FIRE SAFETY INSPECTION REPORT

Factory Name: Pacific Cotton Ltd.

ACCORD ID: 23661

Date: 17th July, 2019.

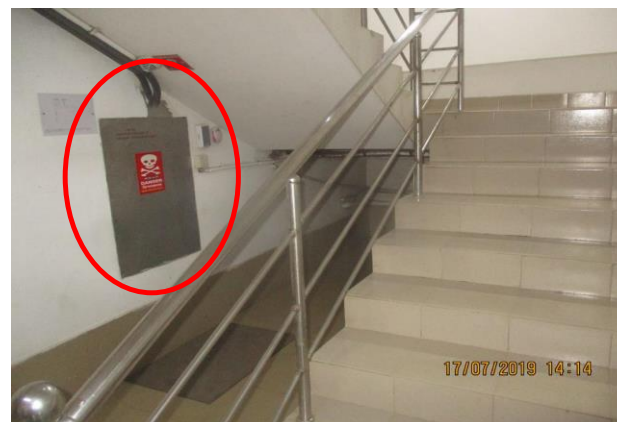
F-02	Fire Rated Construction	Rooms used for storage of combustible materials are not separated from the surrounding occupancy/areas. Location: Building-01 (Garments Building)	Rooms used for storage of combustible materials shall be separated from the surrounding occupancy with a minimum 1 hour construction.	Within 3 months
